RFQ NUMBER
 DEFK7044

ADDENDUM #01

ADDENDUM # 1

PROJECT: KINGWOOD READINESS CENTER
Camp Dawson
Kingwood, West Virginia

DESIGNED BY H. NOURAHANI
DRAWN BY K. SPUDEN
CHECKED BY DGD
REVISION DATE 08/07/06
SHEET NUMBER SDA-A-012

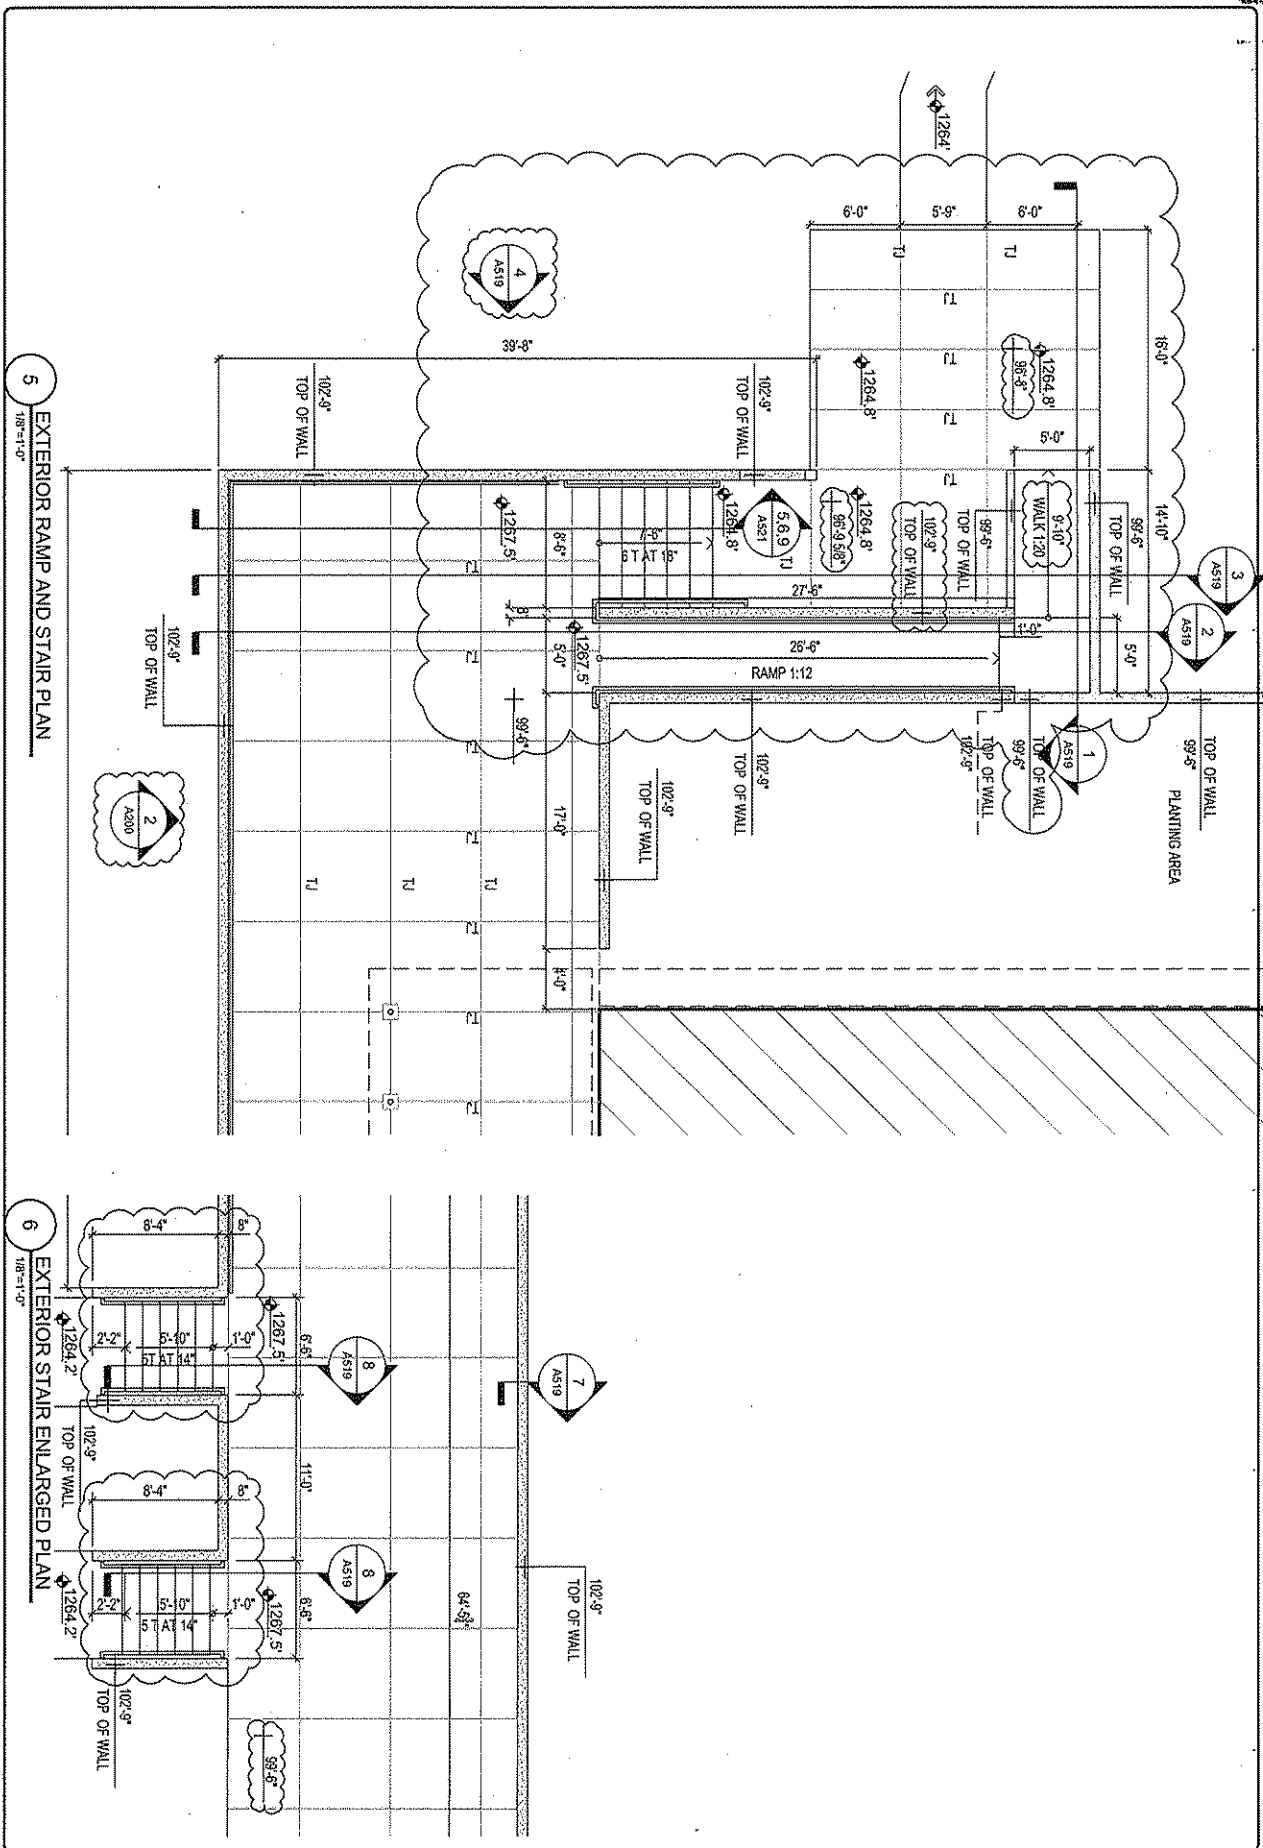
- 01-0035: Delete 5/A519 EXTERIOR RAMP AND STAIR PLAN AND 6/A519 EXTERIOR ENLARGED PLAN and replace with revised drawing per architectural supplemental drawing SD-A-012, attached.

DESIGNED BY:	H. NOUGHAN
DRAWN BY:	K. SPODEN
CHECKED BY:	DOJ
REVISION DATE:	09/07/05
SHEET NUMBER:	SD-A-013

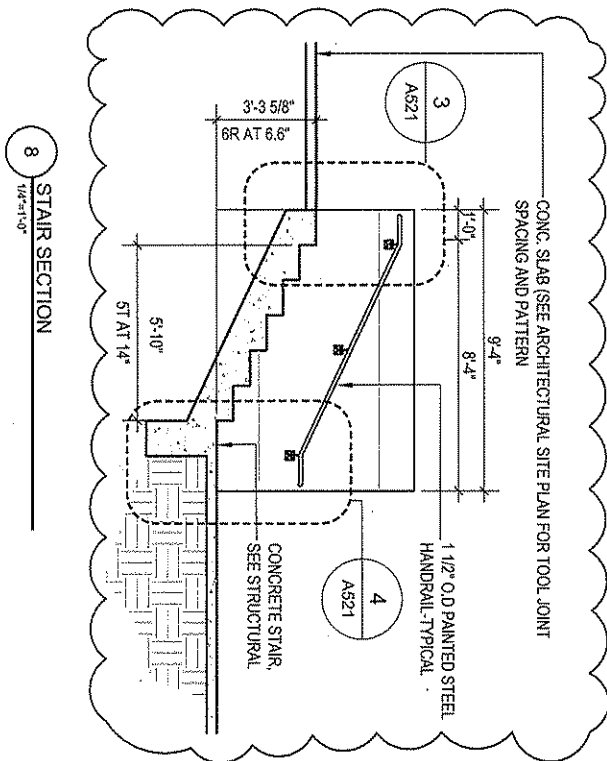
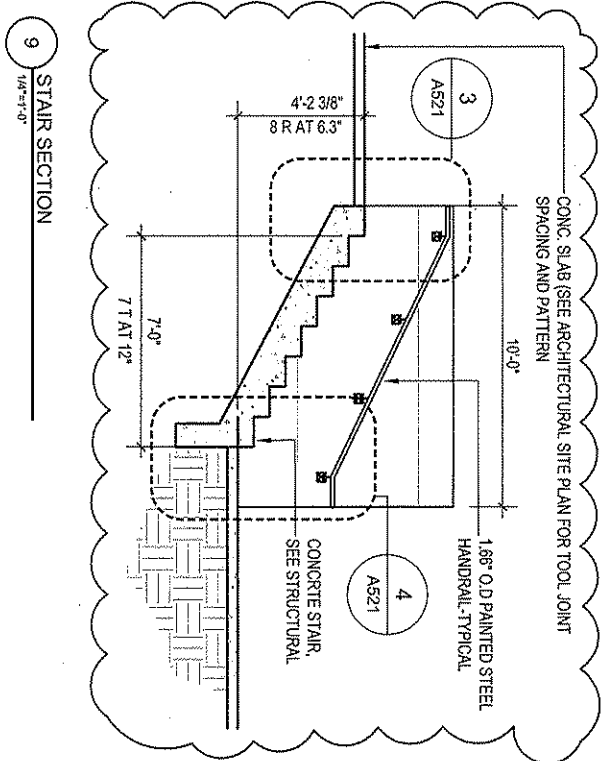
- 01-0036: Delete 8/A519 STAIR SECTION AND 9/A519 STAIR SECTION and replace with revised drawing per architectural supplemental drawing SD-A-013, attached.

SHEET NUMBER:
 SD-A-014

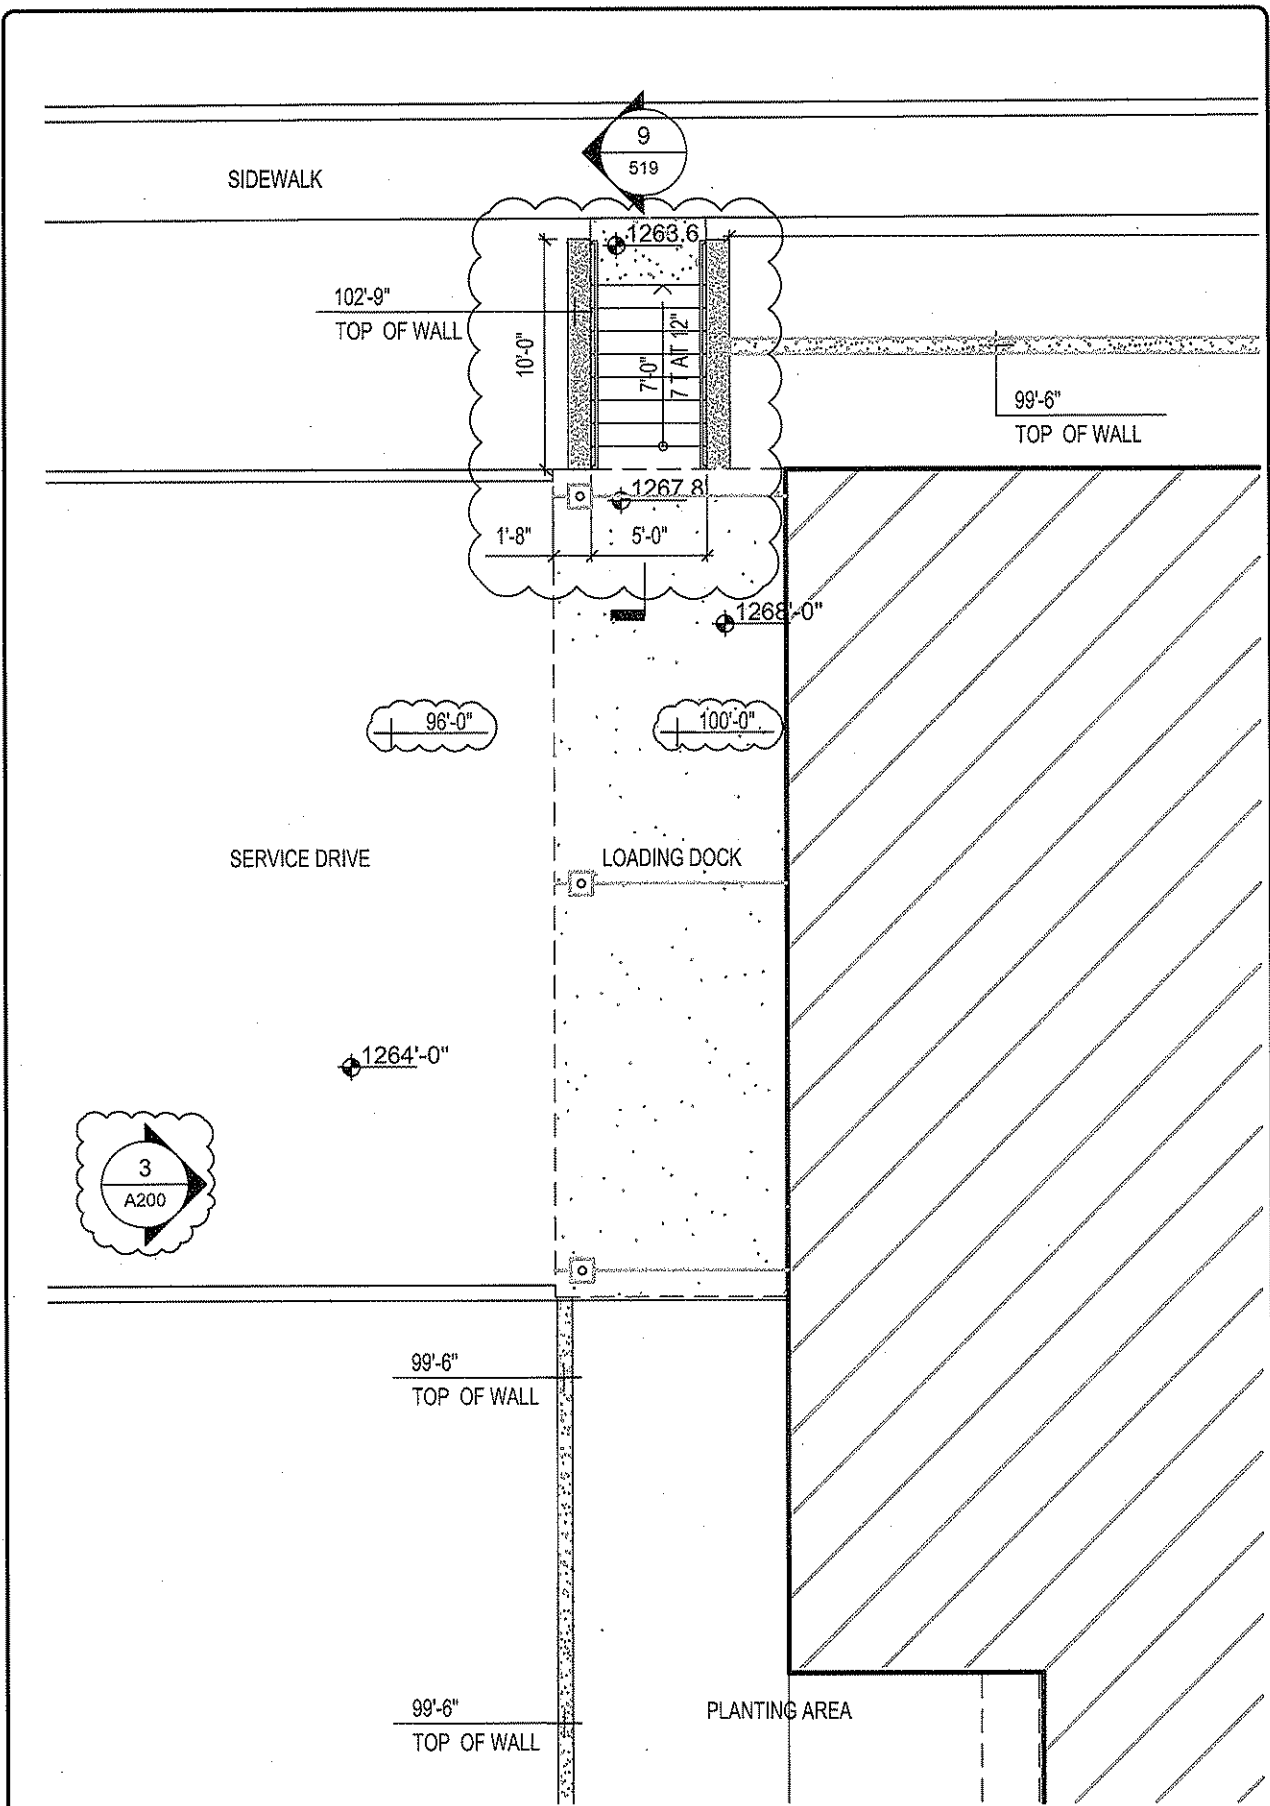
- 01-0037: Add 10/A519 LOADING DOCK AND STAIR PLAN per architectural supplemental drawing SD-A-014.

DESIGNED BY:	H. MOUSAVI
DRAWN BY:	K. SPODEN
CHECKED BY:	DDJ
ISSUANCE DATE:	08/07/08
SHEET NUMBER:	SD-A-015

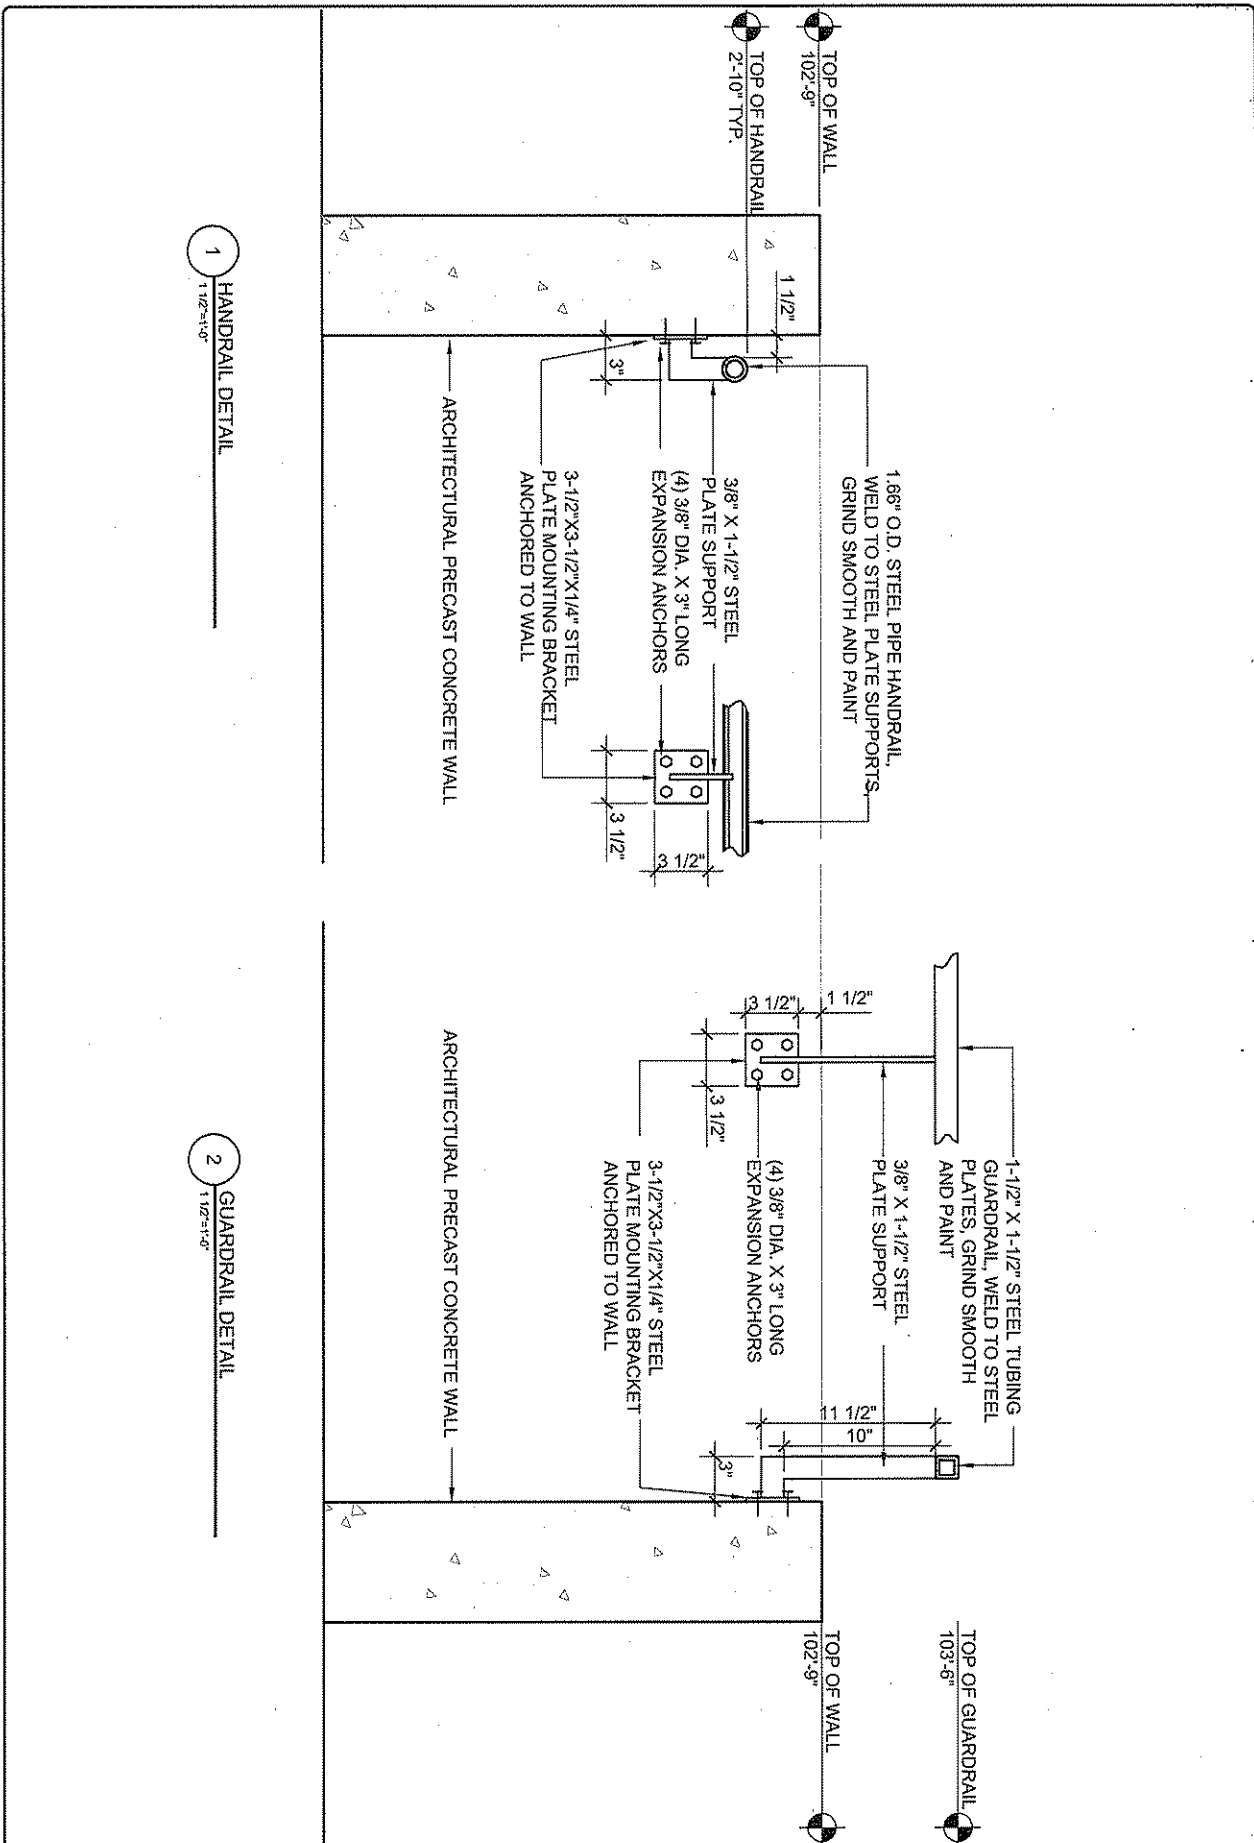
- 01-0038: Add 1/A521 HANDRAIL DETAIL AND 2/A521 GUARDRAIL DETAIL per architectural supplemental drawing SD-A-015, attached.
- 01-0039: Add 3/A521 STAIR HANDRAIL DETAIL AND 4/A521 STAIR HANDRAIL DETAIL per architectural supplemental drawing SD-A-016, attached.

DESIGNED BY: H. NOURCHANI	CHECKED BY: D.D.D.	PROJECT DATE: 08/07/05
DRAWN BY: K. SPUDEN		
SHEET NUMBER: SDA-017

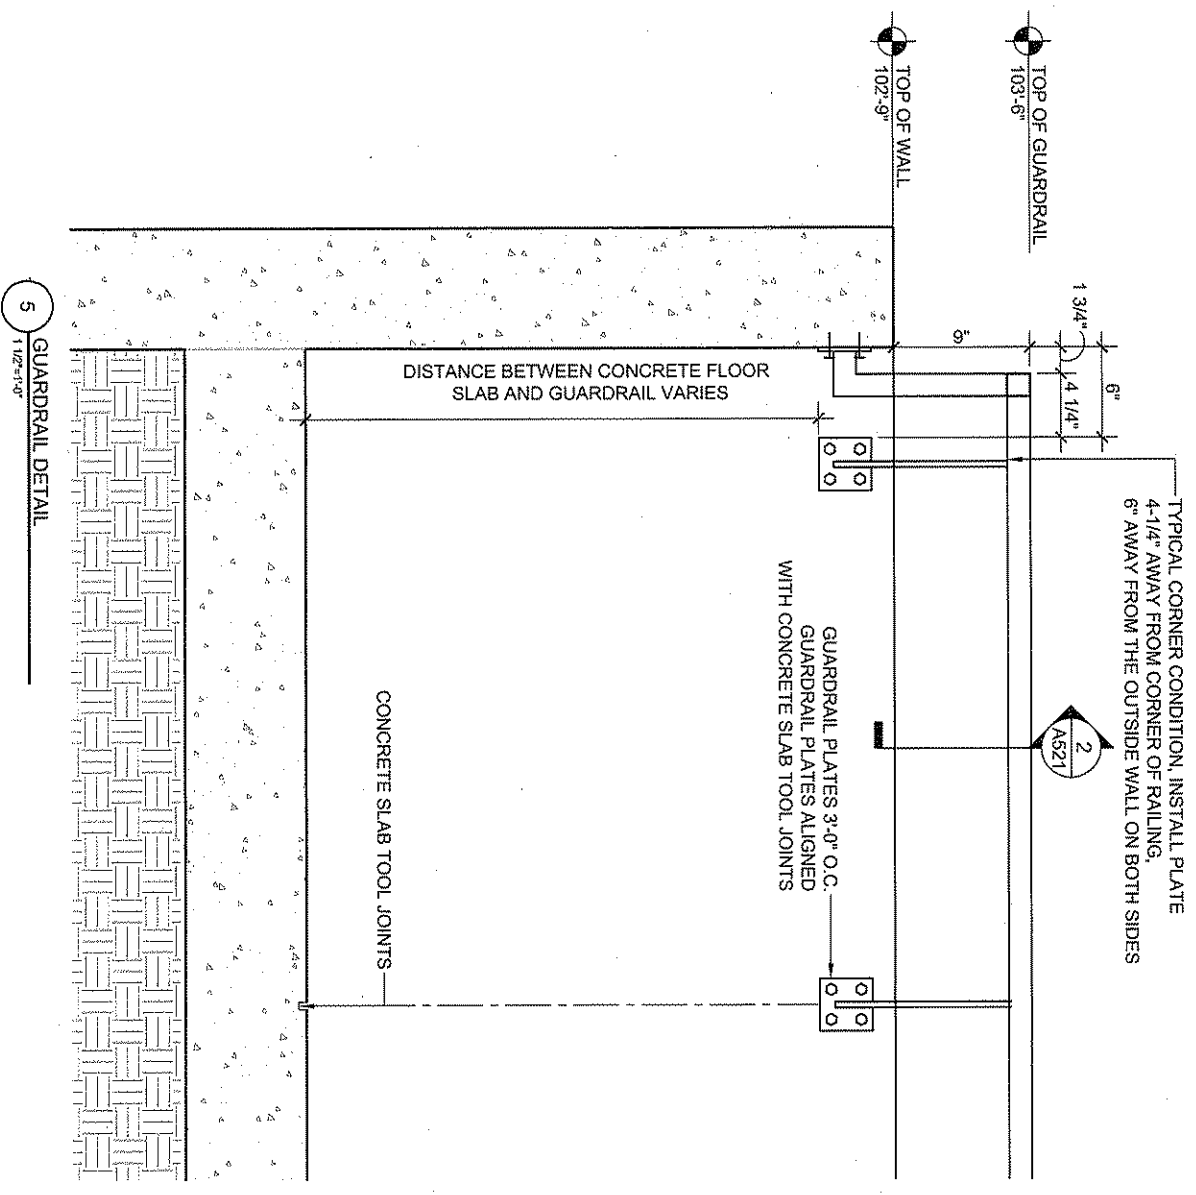
- 01-0040: Add 5/A521 GUARDRAIL DETAIL per architectural supplemental drawing SD-A-017, attached.
- 01-0041: Add 6/A521 GUARDRAIL DETAIL per architectural supplemental drawing SD-A-018, attached.

DESIGNED BY:	H. NOUSHRANI
DRAWN BY:	K. SPODEN
CHECKED BY:	DCD
REVISION DATE:	08/07/06
SHEET NUMBER:	SD-A-019

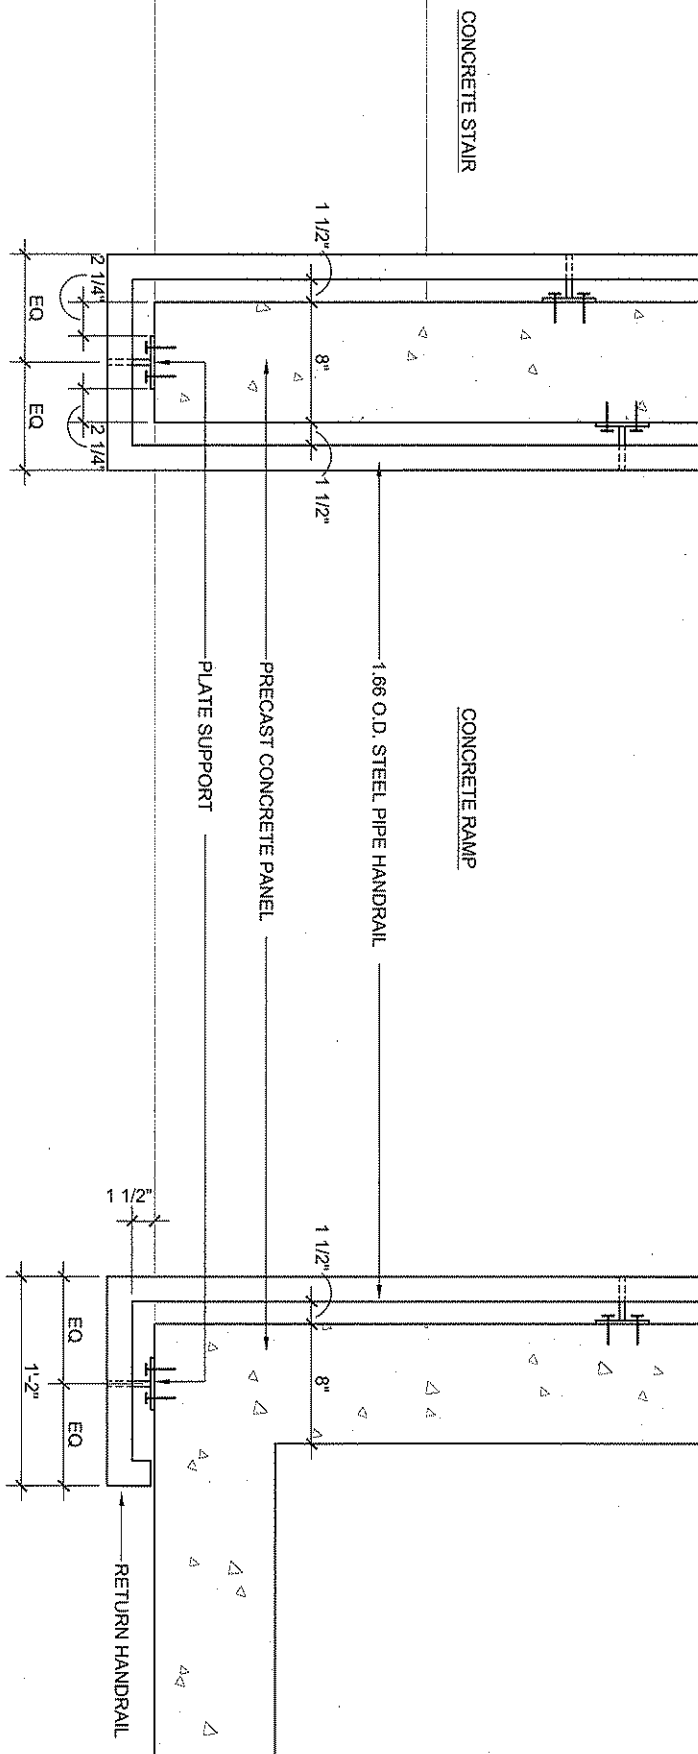
- 01-0042: Add 8/A521 HANDRAIL PLAN DETAIL AND 9/A521 HANDRAIL PLAN DETAIL per architectural supplemental drawing SD-A-019, attached.
- 01-0043: MH-111 FLOOR PLAN – HVAC: Move CUH-1 to southwest wall. Refer to supplemental drawing SD-M-001.
